We would like to thank Dr Ryan Teuling and his students Danny Heuvelink, Judith Poelman and Heleen Westerveld for their critical and constructive comments on our manuscript. We appreciate the time and effort taken to review our manuscript. We would like to address the major issues identified by all the reviewers in a compiled response, and address the minor comments in a revised version of the manuscript. We are confident that the reports will make a positive contribution to the quality of our manuscript.

(1) Use of the minimum over the average monthly soil water pressure as reference for potential plant water stress

Figure 3: Standardised monthly minimum soil water pressure in 5 cm depth and SPI for Cairns, Bourke and Melbourne.

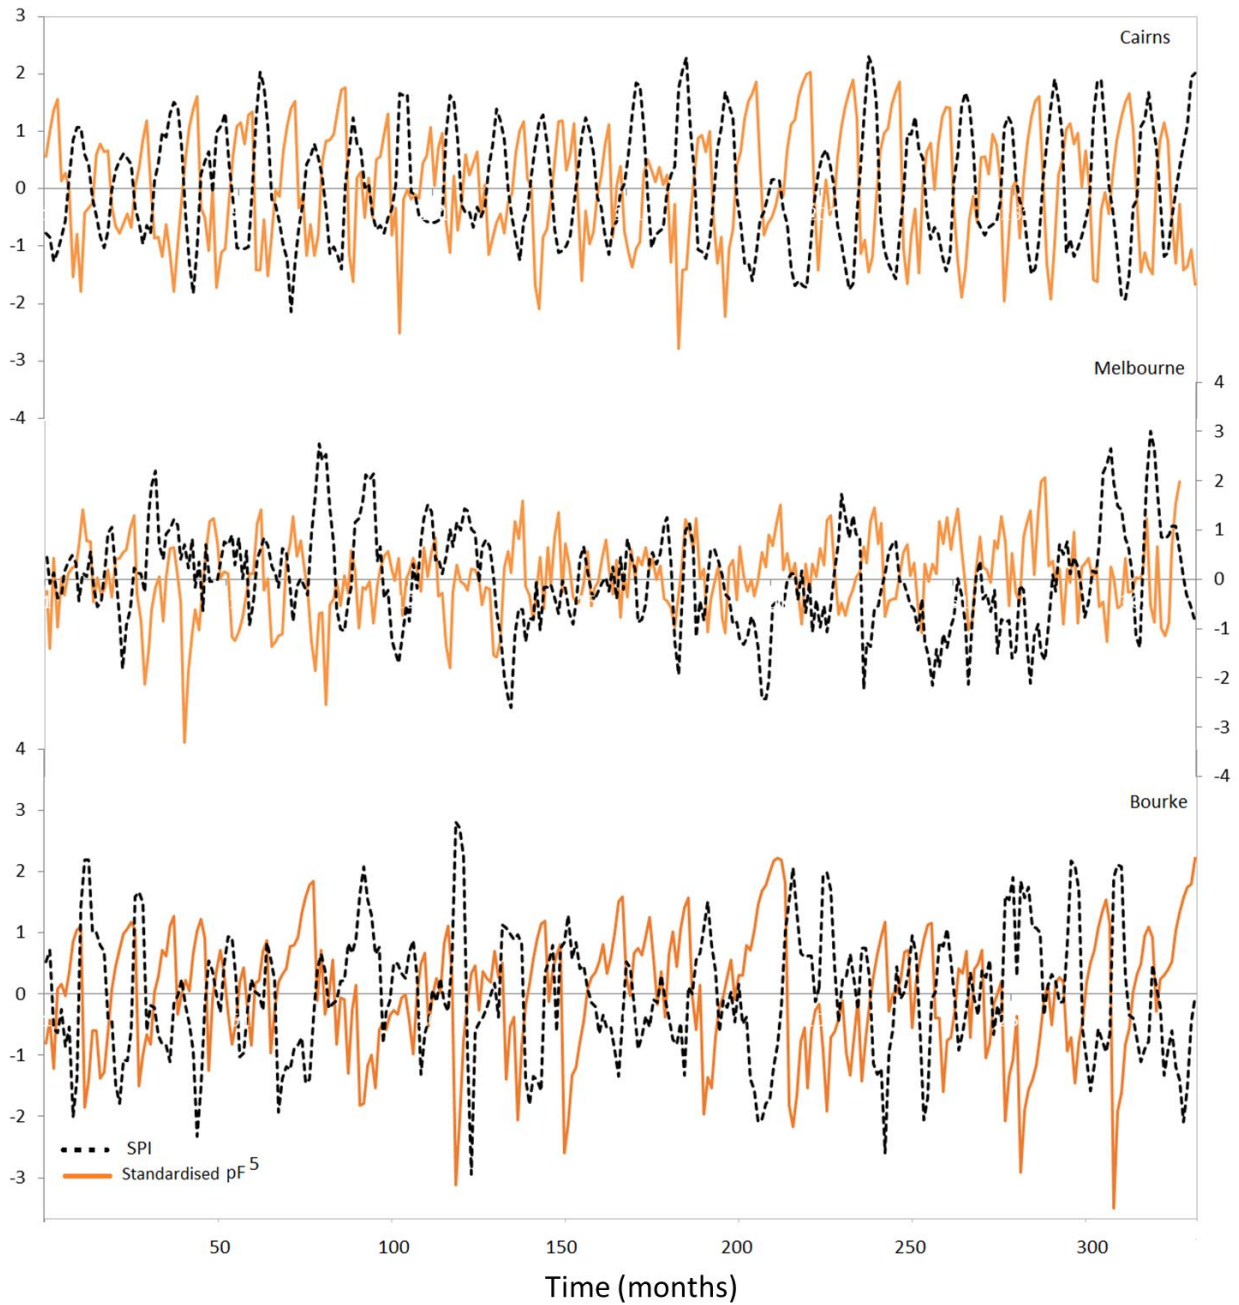
(3) Comparison of standardised indices with simulations of a physically based model or empirical measurements (including the use of the 75th percentile threshold)

The main concern of all reviewers is that the indices are standardised quantities whereas the modelled soil water pressure is an absolute physically relevant metric. As emphasised in our response to Reviewer #1, the SPI is standardised using the long-term average rather than the seasonal averages. Therefore, the standardisation in SPI rescales the data and does not remove seasonal variability, so it is not expected to make much difference to the correlations (only insofar as changing from a skewed to a normalised distribution of values) and cannot affect the FR/FAR values (as the scaling is monotonic). We will emphasise this fact in the revised paper. The use of non-seasonally-standardised indices is not uncommon, (e.g. Martínez-Fernández et al., 2015; Wang et al., 2015; Wang et al., 2016)

For the Reviewers' and Editor's information, we have transformed the modelled pF based on the mean and standard deviation of a normal distribution (Fig. 3). Yet the strength of the relationship
